# PCN-20210510 KK0803-03A to KK0803-04 Hardware Revision Change

<b>Company</b>	Trenz Electronic GmbH
<b>PCN Number</b>	PCN-20210510
<b>Title</b>	KK0803-03A to KK0803-04 Hardware Revision Change
<b>Subject</b>	Hardware Revision Change
<b>Issue Date</b>	2021-05-14

### #1 Changed milled height profile.

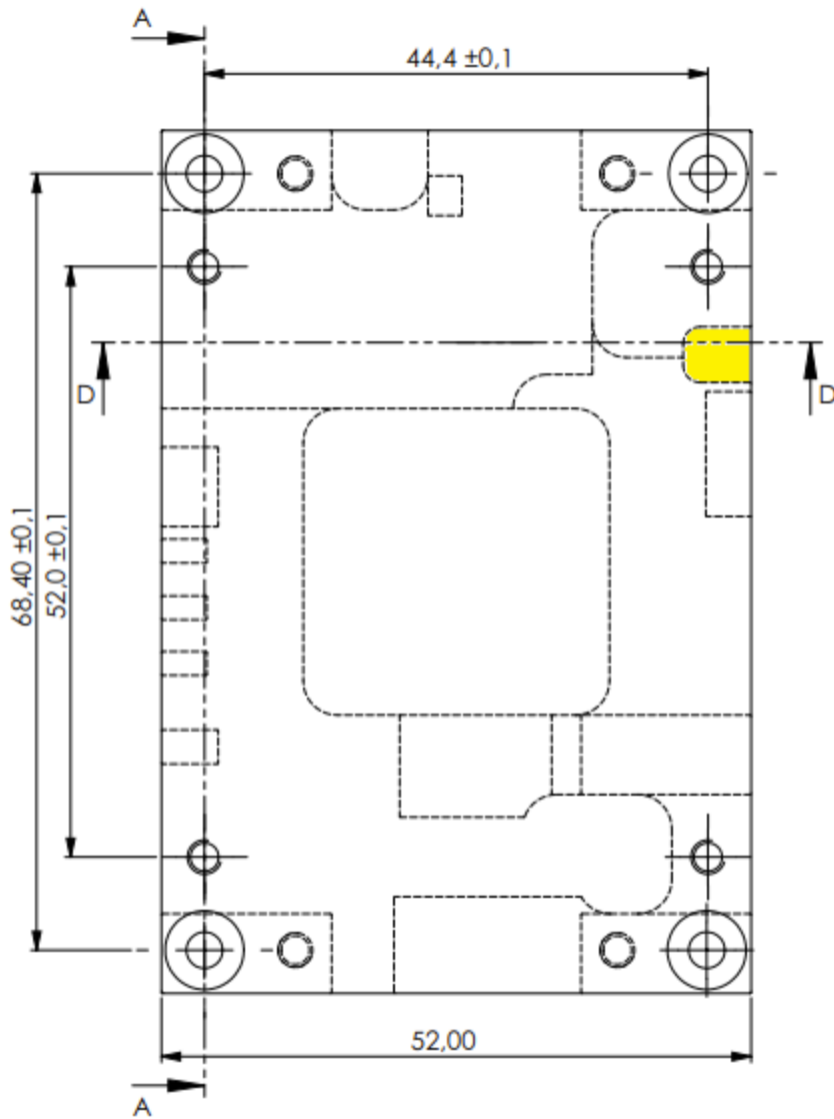
**Reason:** Revision 04 of TE0803 has different skyline and is therefore mechanical not compatible with KK0803-03A.

**Impact:** New heat spreader is compatible with TE0803-04, and also backwards compatible to older versions of TE0803.

Models with the feature marked in yellow are revision 04. Heatspreader without that feature are of older revision and not compatible to TE0803-04.
